Revisions.
 A. Proposed windows to be single glazed. 17/04/17

Proposed Side Elevation facing Southeast

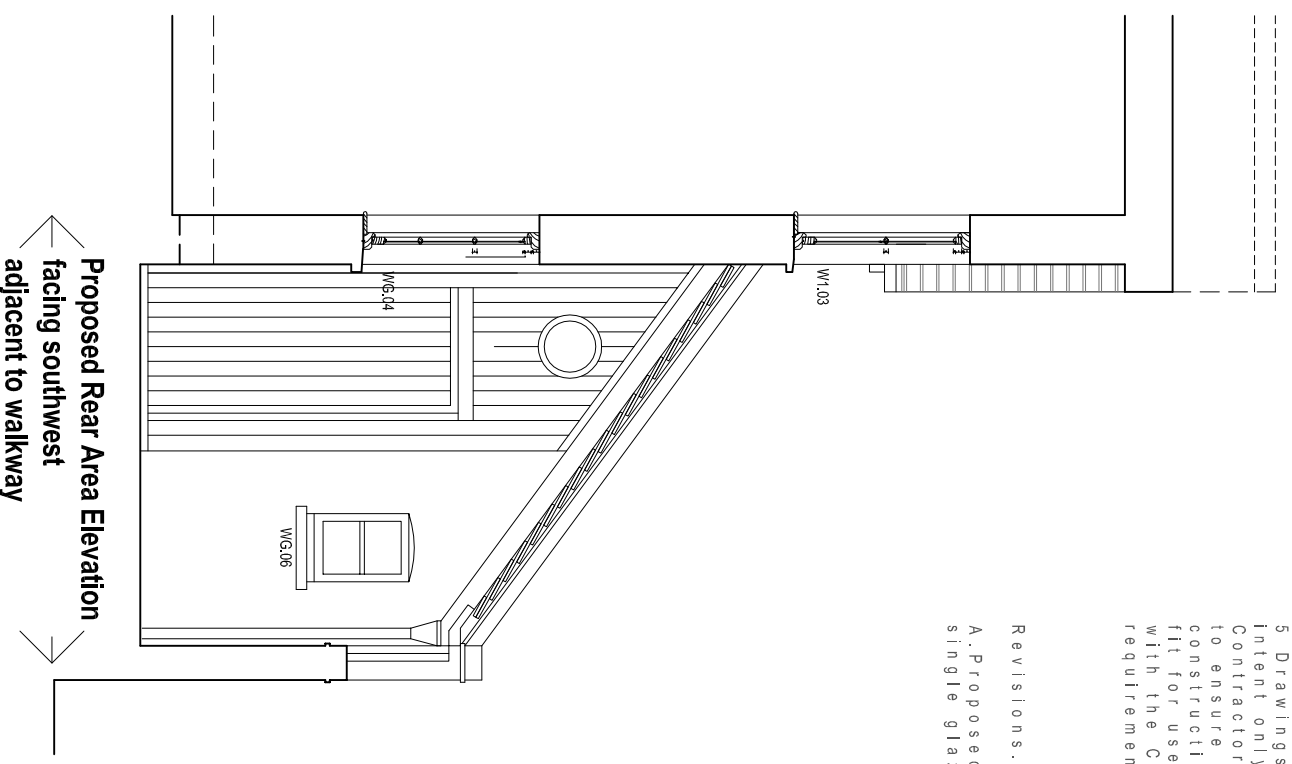
New clear single glazed timber windows to W1.04 and W1.05 to match detail of existing timber window W1.06 with reveal to accommodate 4mm single glazed unit, see detail PR-D01. WG.07 to match details as above but to be obscure glazed with Pilkington Arctic or equal approved.
